OBJECT

Submission ID: 211755

Organisation: N/A	Key issues: <i>Social impacts, Visual impacts, design and landscaping, Land use compatibility (surrounding land uses), Traffic, Other issues</i>
Location: New South Wales 2577	
Attachment: Attached overleaf

Figure 2: Landscape Plan

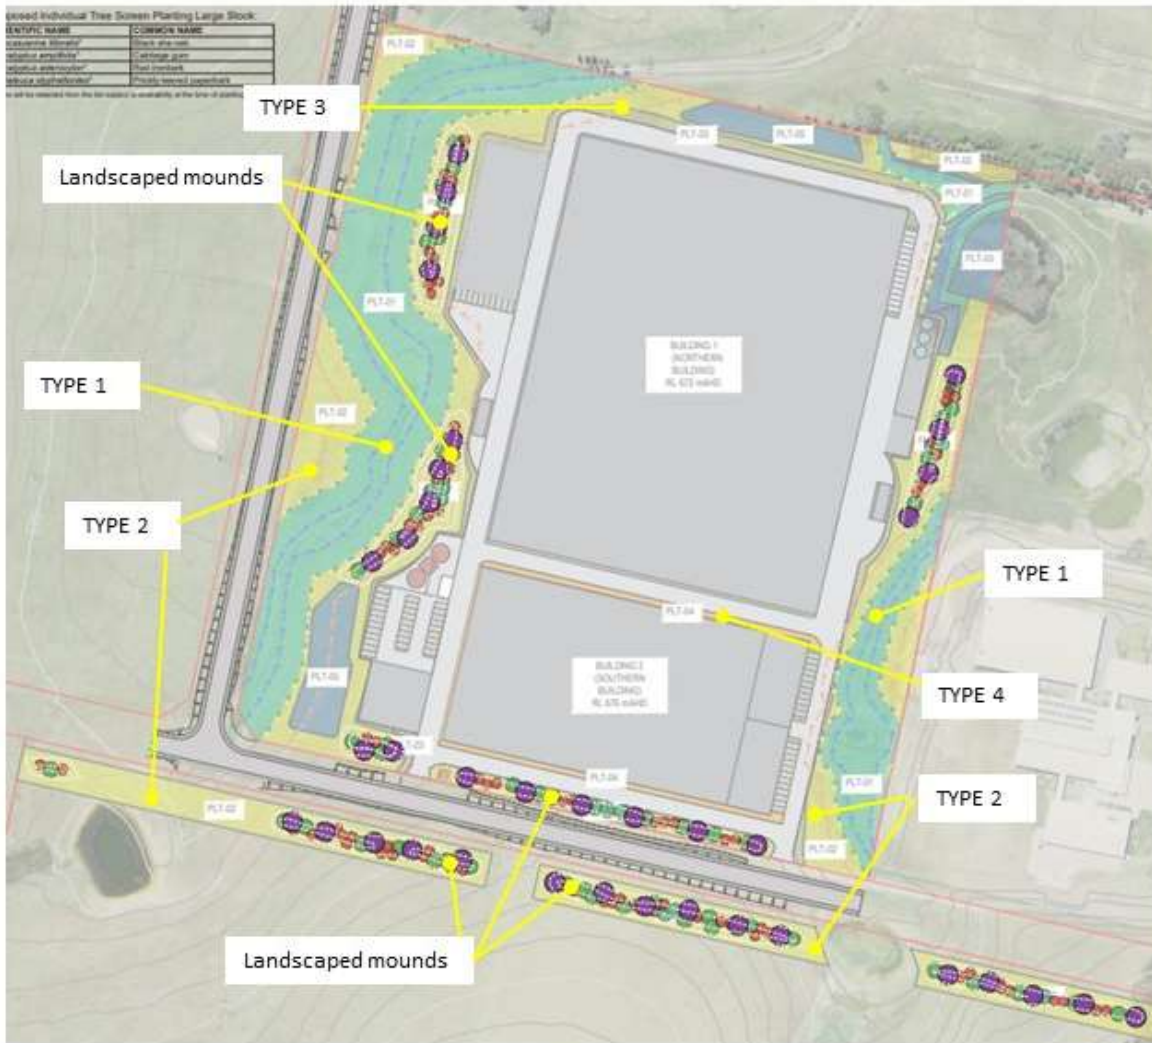
- 2. There is so little space left for significantly sized landscape buffers on southern side of actual development site that they propose landscape mounds on the northern edge of the E4 zoned land. This does not take into account that plants can die from pests and disease nor that any subsequent future owner / developer of the E4 land might remove the mounds / buffers. I note there is a gap left between the proposed mounds on the E4 land. Is this so the proponent is able to use both sections, for whatever reason, with ease?*

Figure 6 | Site Approach and Access (final version)

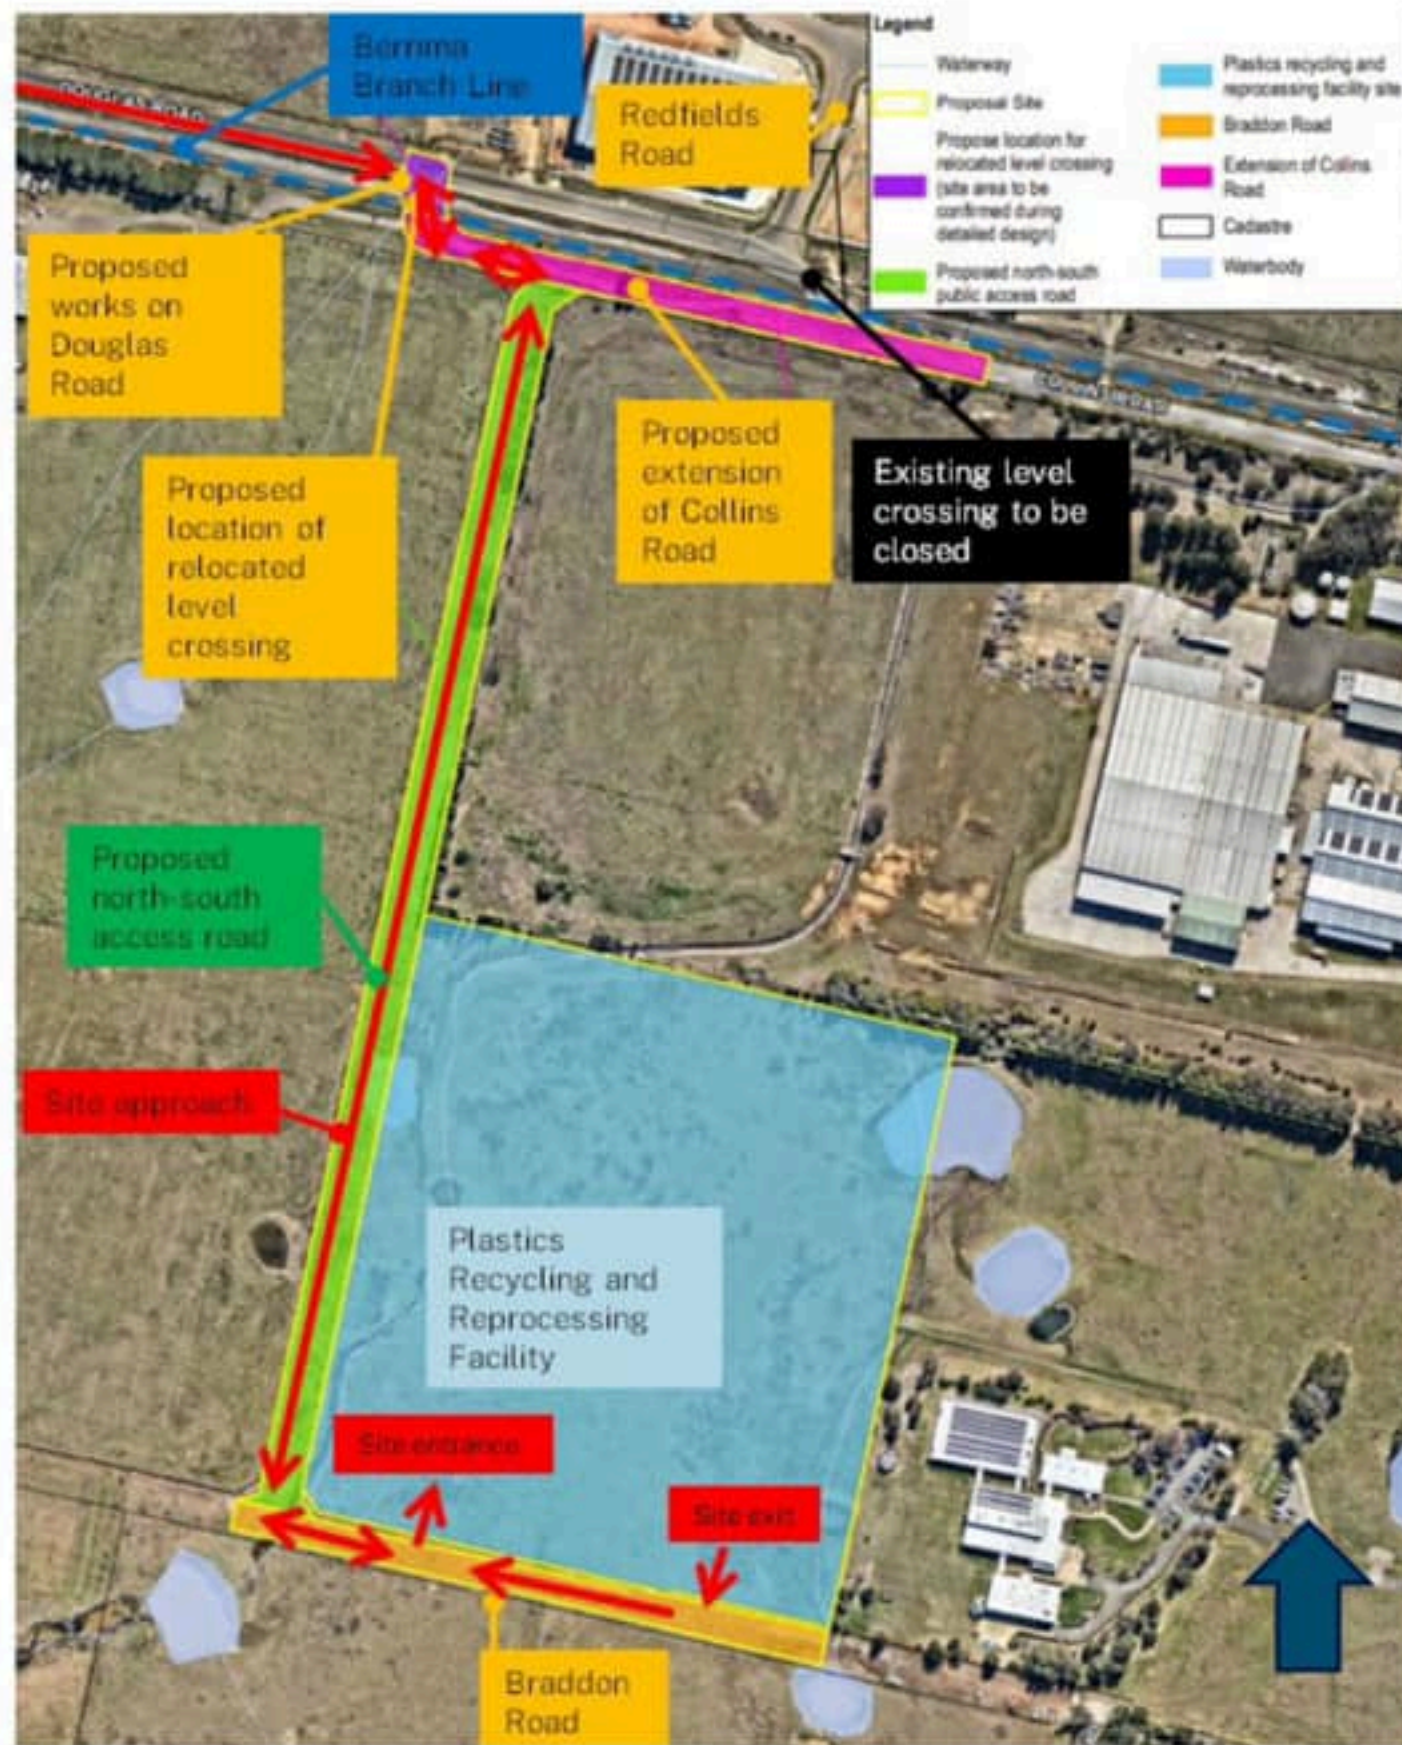
- 1. The newest and final approach has driveway entry and exit facing the residential area to the south / south east ie on Braddon, Beaconsfield and Bulwer Roads. This places an extremely unfair demand and imposition on residents in terms of truck noise (semi trailer? b-double?) at the very least.*

- 3. The proposed driveways facing residents means there's nothing to stop drivers using southern and eastern roads to get to and from the site. This will place an enormous and unfair traffic burden on residents of Beaconsfield Road, Bulwer Road, Stables Place, Horseshoe Lane, Roche Close, Trotters Lane, Garrett Road, Lytton Road, Parkes Road, Watson Road, Innes Road etc..*
